From: John Carr
To: [Ballew, Cassie](#)
Cc: [board \(board@southtabor.org\)](mailto:board@southtabor.org)
Subject: LU 17-144195 DZ: Additional Appellant Evidence/Testimony
Date: Thursday, February 15, 2018 2:17:22 PM
Attachments: [STNA-Additional-Testimony.pdf](#)

South Tabor Neighborhood Association

RE: LU 17-144195 DZ

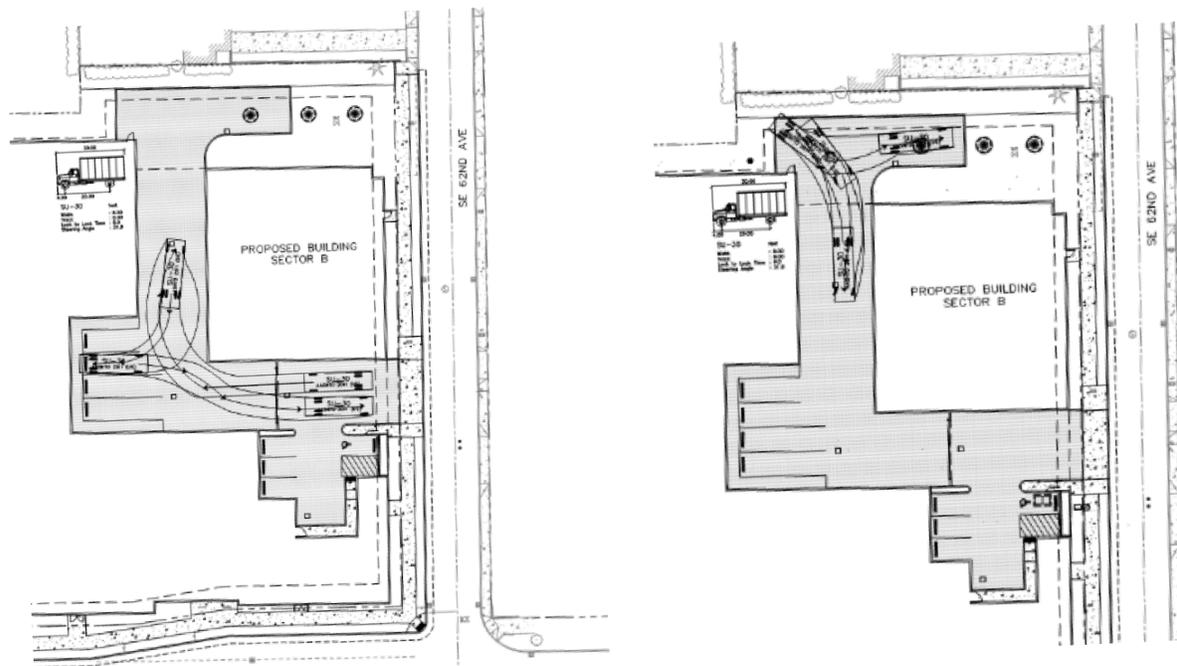
The applicant's summary response to appeal issues (1/22) states: "The use of the turnaround area will be further restricted by the rollup garage door. The applicant proposes to have the garage access be controlled, so that only customers with large trucks who request the gate code will be allowed access to the turnaround area."

Given that the applicant proposes the site be accessible-yet-unattended for several hours each day and all day Sunday, who do they request the gate code from?

There is also the issue of the no parking and no idling signs, which make sense regardless. Those measure acknowledge, but do not solve, the problems we see happening with this area. Again, as we said at the hearing, if this feature of the building relies on the specific

Right-turn only egress onto SE Schiller St. at 4718 SE 82nd Ave. (LU 13-168000 AD)

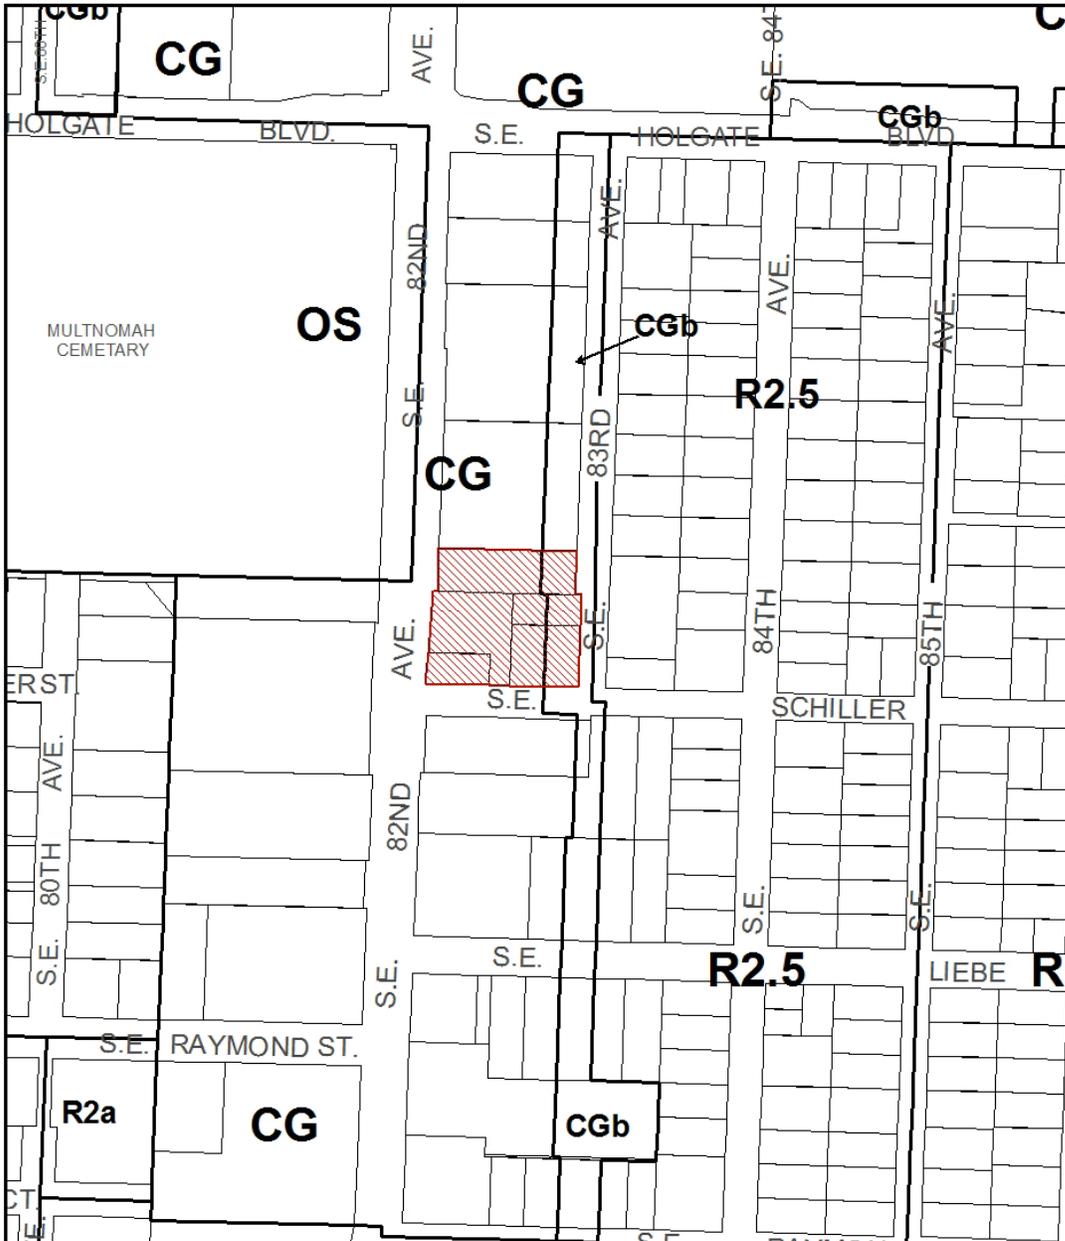
- ❖ We ask the commission to add as a condition of approval that signage and or physical curbs be installed and maintained to prohibit left turns out of the facility and direct all exiting vehicles south towards Powell. This would keep the auto-accommodating use of the building oriented towards the Major City Traffic Street and towards an area "already predominantly built in this manner," rather than north onto the narrowest of our local service streets.

As an example, a similar solution was incorporated at 4718 SE 82nd Ave. during a Type II review (see Appendix B).

Below is a street view of the egress at SE Schiller St., the local service street adjacent to the commercial development. You can see the signage and driveway markings that direct vehicles to stop then turn right when exiting the property.
